CITY OF MERCER ISLAND

RE: Request for Information #2 for File No. SUB21-002 – Angiuli Pacific Res Trust Short Subdivision
4001 West Mercer Way, Mercer Island, WA 98040; King County Tax Parcel # 362350-0365

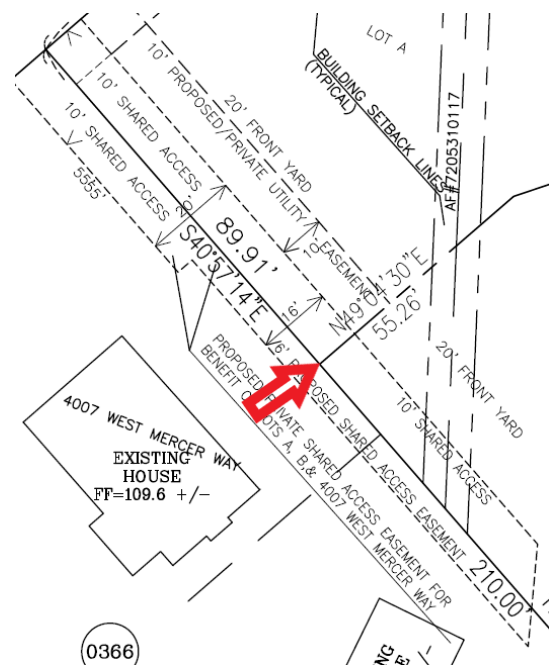
2. Extend the 20’ access easement to the edge of the shared property line between Lot A and Lot B, as illustrated in the image to the right:

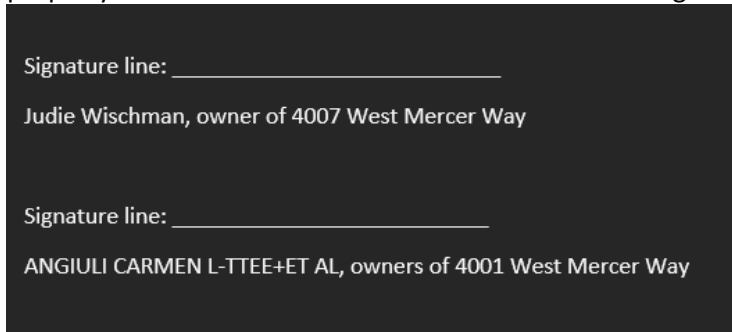
- a. As requested in the first review letter, please include a signature line for the owner of 4007 West Mercer Way, Judie Wischman. Currently, there are 4 name lines that are blank. Please note the property owners' names and address below the blank signature line as shown below:
